REF: ERC0222

## **GENERATOR TECHNICAL PERFORMANCE STANDARDS – INITIAL CONSULTATION**

Origin Energy Limited (Origin) welcomes the opportunity to respond to the Australian Energy Market Commission's (AEMC) consultation paper on changes to the generator technical performance standards for the National Electricity Market (NEM).

Figure 5 Proposed system standard for power frequency over voltage

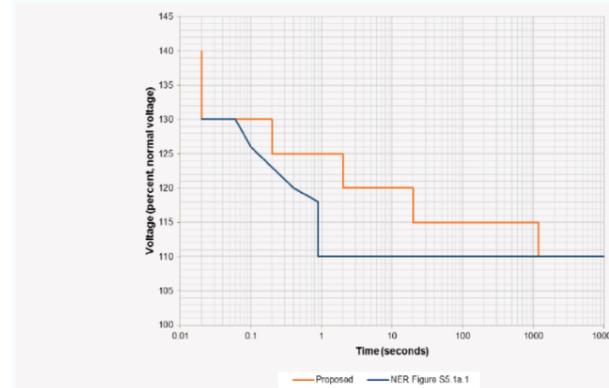
<p>“Reasonable” assessment will need to specify criteria to enable existing generators to continue operating. For example: doesn’t impact other standards; doesn’t change fundamental operation; doesn’t impact system security beyond existing; costs (e.g. additional relays + training etc.); doesn’t risk physical damage to unit; provides technological improvement (e.g. predictive PSS).</p> <p>A pragmatic approach would be to design and utilise a set of standards that considers a generators location.</p>
System Standards	S5.1a.4	Power Frequency Voltage and Fig S5.1.a.1	33			<p>Origin does not support the proposed frequency over voltage curve.</p> <p>Meeting this proposal would have unintended consequences of requiring existing generators to adjust their voltage ride through settings. Origin would need to review each of our generators to ensure that this curve could be met.</p> <p>Should the Generator Performance Standards (GPS) be modified it would represent a significant and unexpected cost which could hasten retirement of plant.</p> <p>Existing units require investigation – as well as capability of the connecting transformer. The older assets will need thinking as to impacts on auxiliary plant.</p> <p>The higher speed voltage is an issue for the transformers, but the slower speed voltages are the issue for the balance of the plant. This will remain an issue for older plant and cannot be updated without significant works.</p> <p>If the changes are small (depends on site arrangements), the additional costs would be per transformer ~\$500k, but auxiliary impacts are extremely hard to quantify.</p> <p>If we had to replace transformers, this is \$5M per transformer at Eraring plus the loss of production.</p> <p>AEMO need to maintain the consistency in language between normal and nominal voltage by nominating one or the other in their</p>

documentation. Switching between these two terms can result in increased requirements, sometimes from 10% to 18%. This makes it difficult to design a system that can meet these needs and increased costs.
Voltage Control	S5.2.5.1	Reactive Power Capability	23-24	S5.2.5.1, S5.2.5.5	<p>Sufficient dynamic reactive power support close to each connection point prevents the propagation of voltage dips across the network and reduces the risk of consequential voltage instability or widespread generation disconnections.</p> <p>Auto Stds: capacity reactive current of up to 4% of the max continuous current of the gen system (in the absence of a disturbance) for each 1% reduction of connection point voltage.</p> <p>Min Std: Does not require a generating system to provide any form of reactive power support during a disturbance.</p>	<p><b>Auto Std:</b> 4% max continuous current for each 1% reduction of connection point voltage below 90% of normal voltage.</p> <p><b>Min Std:</b> must supply additional capacitive reactive current (reactive injection) of 2% for each 1% reduction below 90% of normal voltage.</p> <p><b>All access stds require:</b></p> <ul style="list-style-type: none"> <li>- reactive current injection may be limited to 100% of the rated current of an asynchronous generator, and 250% of a synchronous. Must be maintained within 90-110% of normal voltage until the connection point voltage returns.</li> <li>- a rise time of no greater than 30ms and a settling time no greater than 60ms.</li> <li>- Reactive power consumption upon application of a fault must not exceed 5% of max continuous rated current.</li> </ul>	Not of significant concern, there could be some technical issues around achieving this but likely will not require an excessive outlay.
